Access Compliance Report Public Rights-of-Way (Curb Ramps)

Intersection ID: 42454 Main Street: HONOR_GUARD_AV Cross Street: KINGSLEY_VIEW_DR Location: W

ADA ID: 99A9F7C91218 Ramp Type: PerpDiag Initial Pass/Fail: Fail Overall Compliance: No Severity Score: 72.5

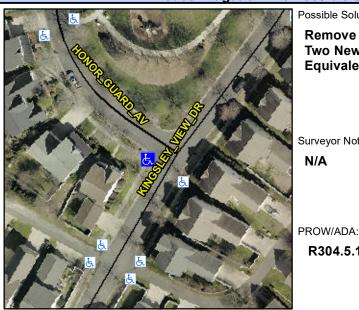
Remove & Replace Curb Ramp With Two New Directional Ramps or Equivalent.

R304.5.1, R304.2.2, R304.5.3

No N/A Ramp Length (in) 74.0 Ramp Slope (%) 9.6 No Ramp XSlope (%) No Ramp Width (in) 29.0 8.0 N/A N/A Flare Type LT N/A Flare Type RT N/A N/A N/A N/A Flare Slope RT (%) N/A Flare Slope LT (%) N/A Flare Traversable LT? N/A N/A Flare Traversable RT? N/A N/A N/A N/A DWS Provided? N/A Landing Length (in) N/A Landing Width (in) N/A N/A **DWS Contrast?** N/A N/A N/A N/A Landing Slope (%) DWS Length (in) N/A N/A Landing X Slope (%) N/A N/A DWS Full Width? N/A N/A Landing Curb? (Y/N) N/A N/A DWS Offset (in) N/A N/A N/A Shared Landing? N/A Gutter Ponding? N/A N/A Gutter Slope (%) N/A N/A Gutter Lip Ht (in) N/A N/A Gutter X Slope (%) N/A N/A Painted X Walk1? No N/A Painted X Walk2? No X Walk 1 Direction To SE X Walk 2 Direction To NE N/A N/A X Walk 1 Width (in) X Walk 2 Width (in) N/A X Walk 1 Slope (%) X Walk 2 Slope (%) 2.4 8.4 X Walk 1 X Slope (%) 6.3 X Walk 2 X Slope (%) 0.5 N/A N/A N/A Ramp inside XWalk2? N/A Ramp inside XWalk1? Road Slope (%) 4.8 N/A Clear Space? N/A N/A Road X Slope (%) 5.9 Clear Space to XWalk (in) N/A N/A N/A N/A Any Obstructions? Storm Grate/Utility Hazard? N/A **Obstruction Type** Storm Grate/Utility Type N/A N/A
